BUILDING INSPECTION

has permission to Install duct for exhaust hood system

AT 28 PREBLE ST

City of Portland, Maine - Building or Use Permit

Additional Drawing As Requested by Mike Nugent on 8/17/06

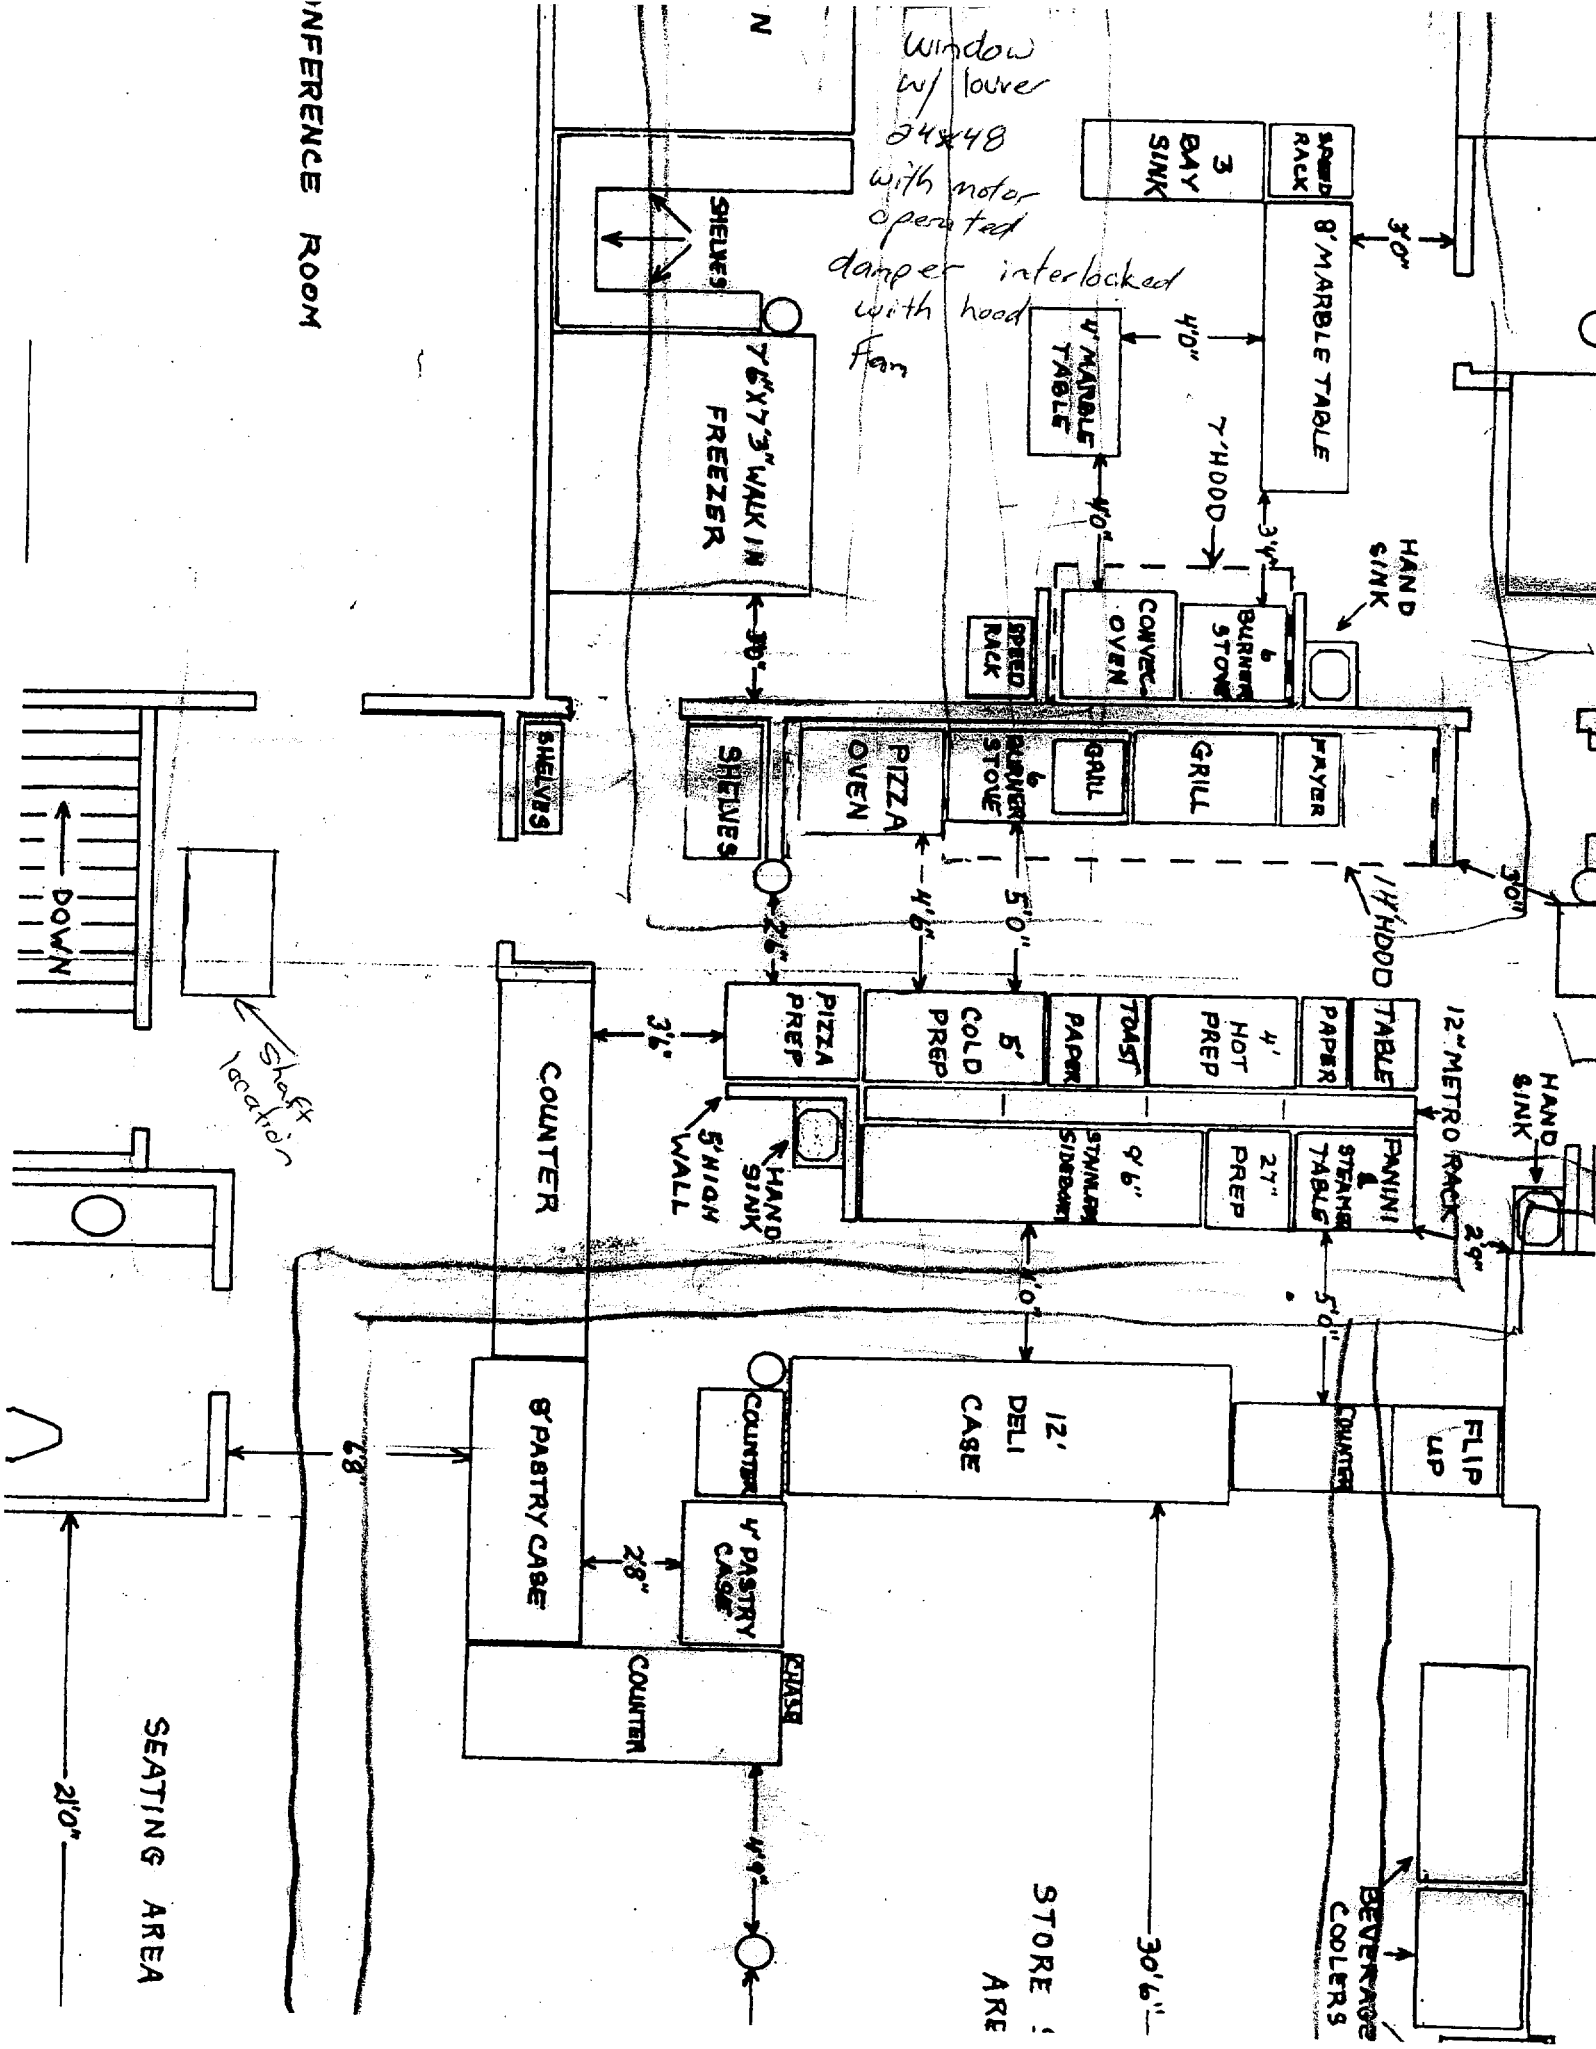
Comments:
8/23/2006-mjn: Left message, inadequate plans, no checklist etc.
8/28/2006-ldobson: Additional information received and routed to MJN
8/17/2006-mjn: advised applicant that we require better job specific plans.

Window w/ louver
24x48
with motor
operated
damper interlocked
with hood
fan

Shaft
location

Detail

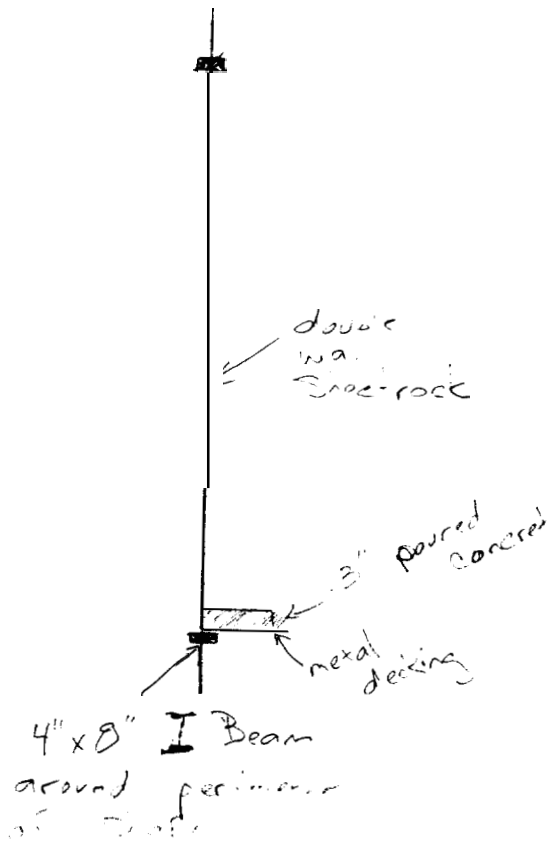
Dept: Fire	Status: Approved with Conditions	Reviewer: Cptn Greg Cass	Approval Date: 08/22/2006
Note:	Ok to Issue: <input type="checkbox"/>		
1) Details required for construction of 2 hr. Rated shaft.			
2) need required clean out locations for duct work shown on plan.			
3) NFPA 96 compliance required

3000-rod / Floor =
40 x 20 / 16 usage =
20 = linear foot =
3000[#] of
door supported
with 2x2 angle
@ shaft cord out
